**SERVICE INFORMATION LETTER NO. SI62-018**

Aircraft: DA 62

Fuel hose labeled with incorrect P/N

Figure 1: Left - location of fuel hose. Note the orange protective sleeve around the hose. Right - fuel hose without protective sleeve, see metallic band for the hose's part number.

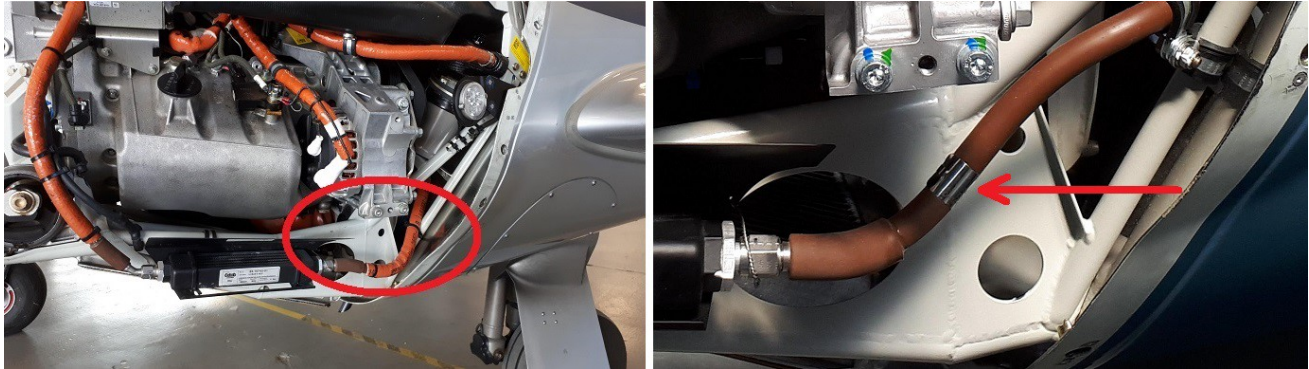
It has come to DAI's attention during maintenance actions that some DA 62 airplanes may have fuel hoses labeled with an incorrect part number. The hose in question is located on the left hand side of the engine, and runs to the fuel cooler from the firewall; see the figures that follow.

NOTE: The installed hose is the correct part, but was mislabeled; a hose with the incorrect part number will not fit properly. This letter was prepared to prevent customers from ordering the incorrect hose should the installed hose need replacing.

The fuel hose shown in Figure 1, below, may be labeled with an incorrect part number. The correct part number for the hose is A24481-02, as shown in Figure 2. Some DA 62 airplanes may have hoses labeled incorrectly with a part number of A24481-01. If the fuel hose shown in the figures needs to be replaced, make sure to order and install the correct hose, part number A24481-02.

Figure 2: Fuel hose with correct part number A24481-02 (second line from top).
